**ARCHITECTURE
+ ACCESSIBILITY**

ACCESSIBILITY AUDITS

WAREHAM, MA

Police Station

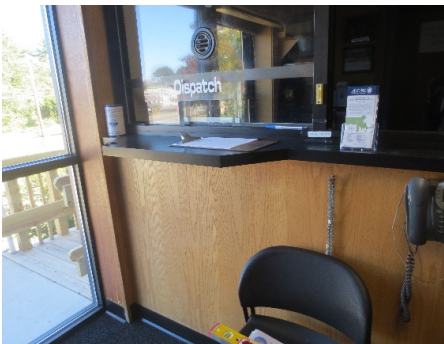
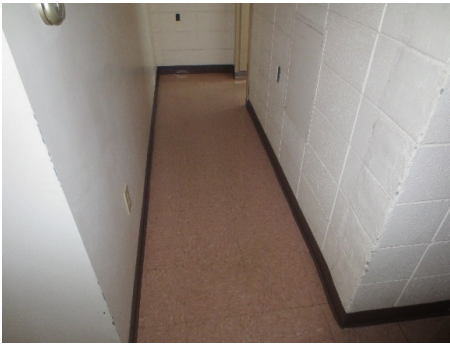
Police Station				
5.	Accessible Parking The designated accessible parking space and the associated access aisles have slope >2%, @ up to 3.8%.	Re-grade the parking spaces and their associated access aisle. Unit Cost: \$1,500 per space or aisle Quantity: 2 (1 space + 1 aisle)		\$3,000
6.	Curb Ramp The bottom surface of the curb ramp is uneven/ broken.	Re-build the curb ramp. Unit Cost: \$1,250 ea. Quantity: 1		\$1,250

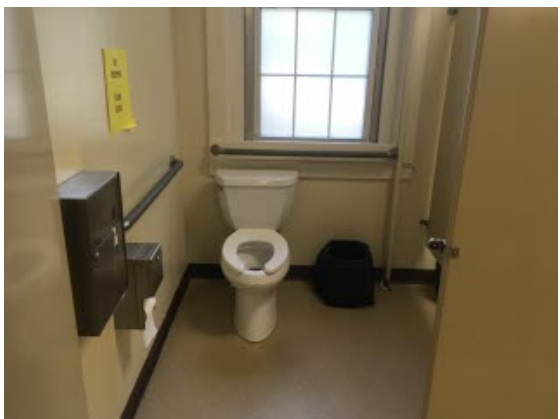
21.	Freight Building Entrances <ul style="list-style-type: none"> The wooden ramp is not located on an accessible route, due to the grass surface. Additionally, the ramp has running slopes >8.3%, @ up to 12.6%, and cross slopes >2%, @ up to 2.6%. The handrails are not rounded and lack the required extensions. One entrance is inaccessible due to the stairs. The paved sloped walkway entry has running slopes >5%, @ up to 5.9%. 	Rebuild the ramp. Unit Cost: \$15,000 ea. Quantity: 1 Install compliant handrails and handrail extensions on both sides of the stairs. Unit Cost: \$50/lf Est. Quantity: 10 lf Provide directional signage at the two (2) inaccessible entrances (stairs and sloped walkway). Unit Cost: \$100 ea. Quantity: 2	 	\$15,000 \$500 \$200

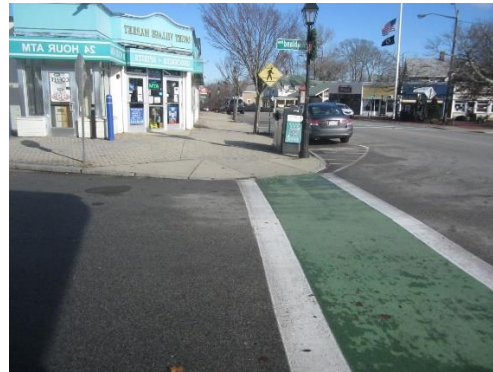
- Ramp cross slope > 2% (@ up to 2.4%)
- Landing at top of ramp is not level (@ up to 2.4%)
- Broken or uneven surfaces
- Changes in level > ½" (@ up to ¾")

The curb ramp on the North side of Marion Road at Viking drive is not functionally accessible due to the extreme slope – both running and cross slope.

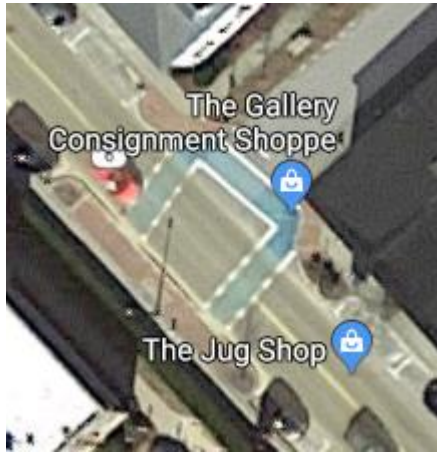
Marion Rd. at Drive to Library This intersection has curb ramps with some sections of broken and uneven surface.

Marion Rd. at Viking Drive One curb ramp at this intersection has a running slope > 8.33% (@16%) and cross-slope > 2% (@5%). The other curb ramp has some sections of broken and uneven surface
